A G E N D A CANBY PLANNING COMMISSION REGULAR MEETING

-STAFF REPORT-

DR 95-06

Northwest corner of N. Baker Street and N.W. 3rd Avenue

FIGURE
4 EXHIBIT

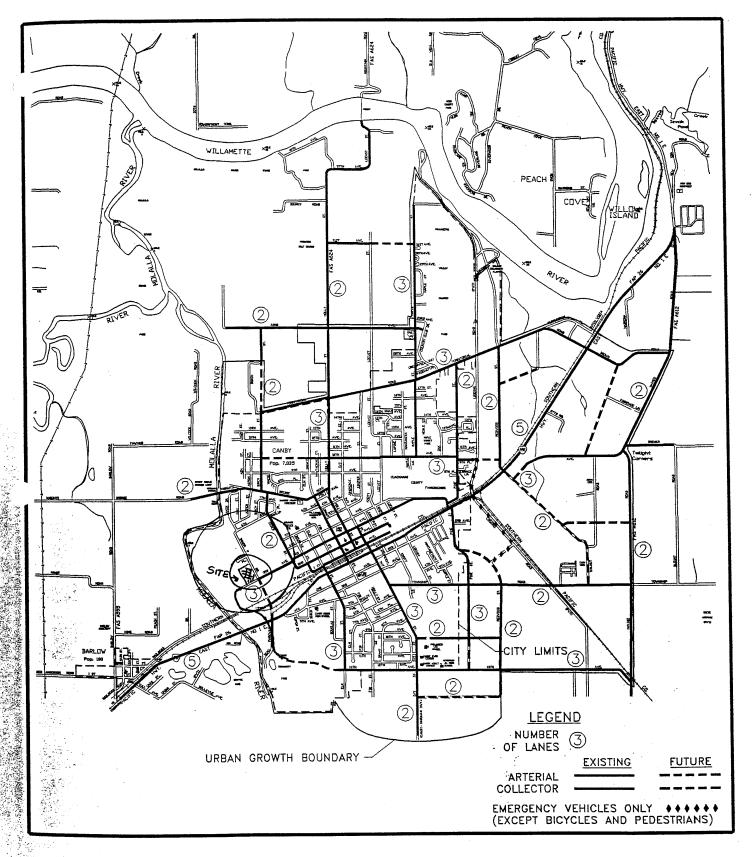
RECOMMENDED COLLECTOR/ARTERIAL STREET SYSTEM
